ADDENDUM NO. 1

Date: September 28, 2023

Project: Multipurpose Laboratory Building

Job No.: 24600-01

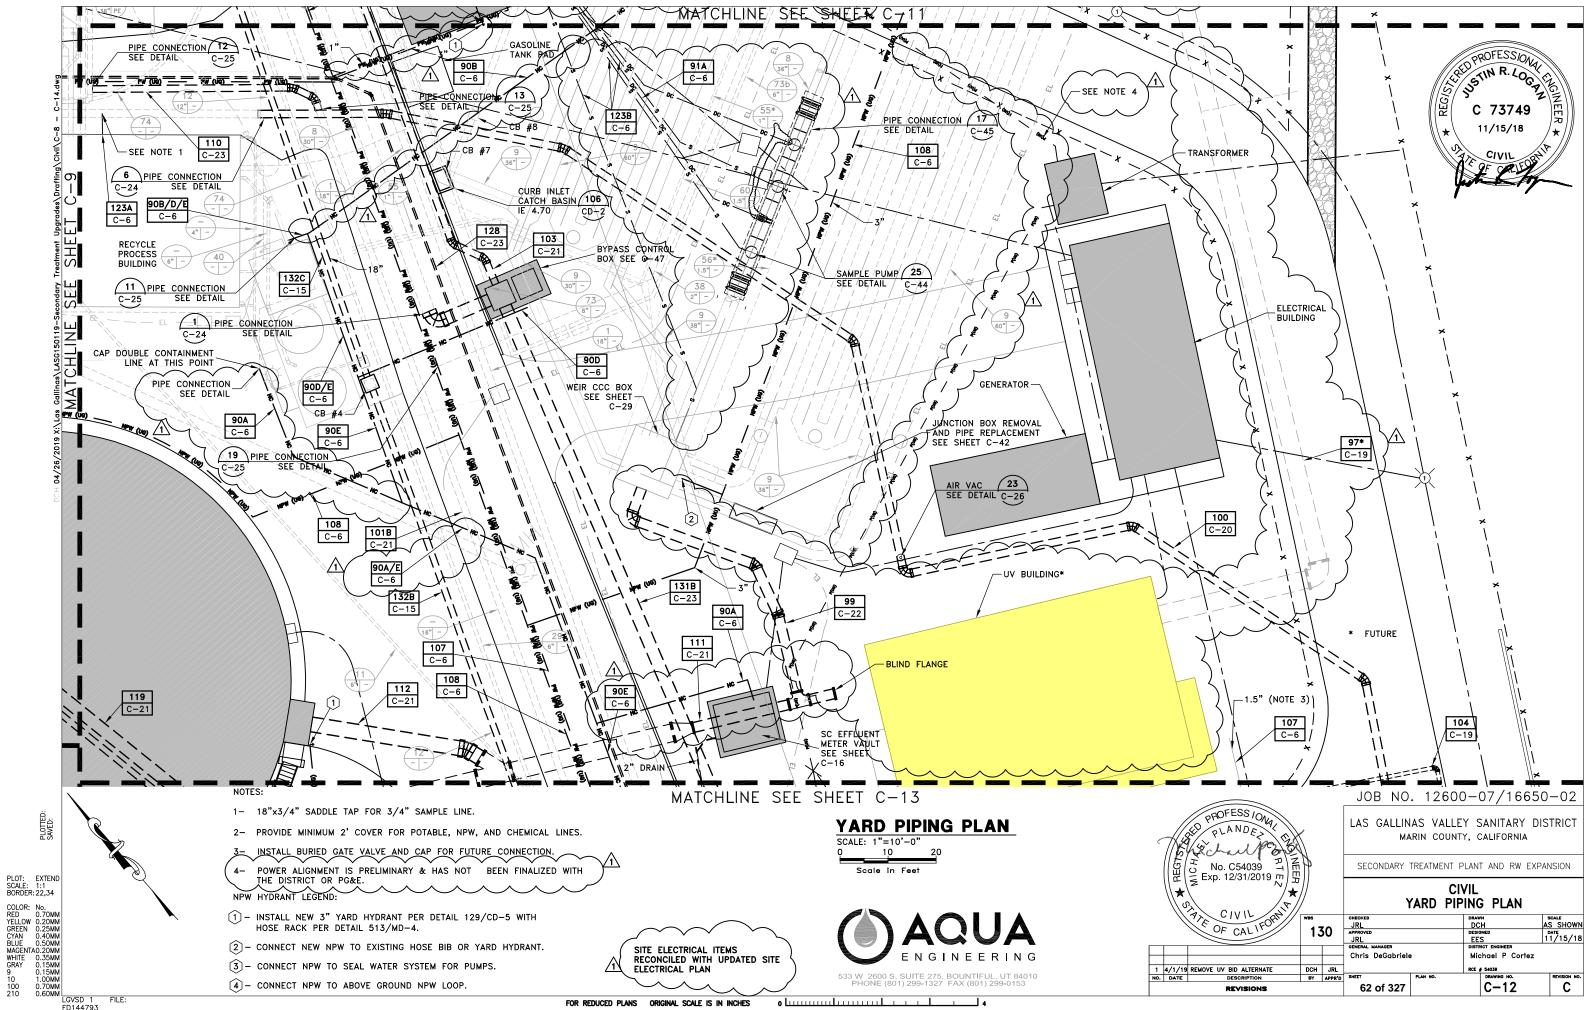
- 2. <u>Sea Level Rise</u> For the purpose of presenting a representative building, the selected consultant shall use finished first floor elevation of 18.0'. Proposers shall include in the approach a description of how to blend the building surroundings at existing ground elevation of 14'± in respect to ADA compliance and the future underground ultraviolet (UV) piping shown in Attachment 1 of this addendum.
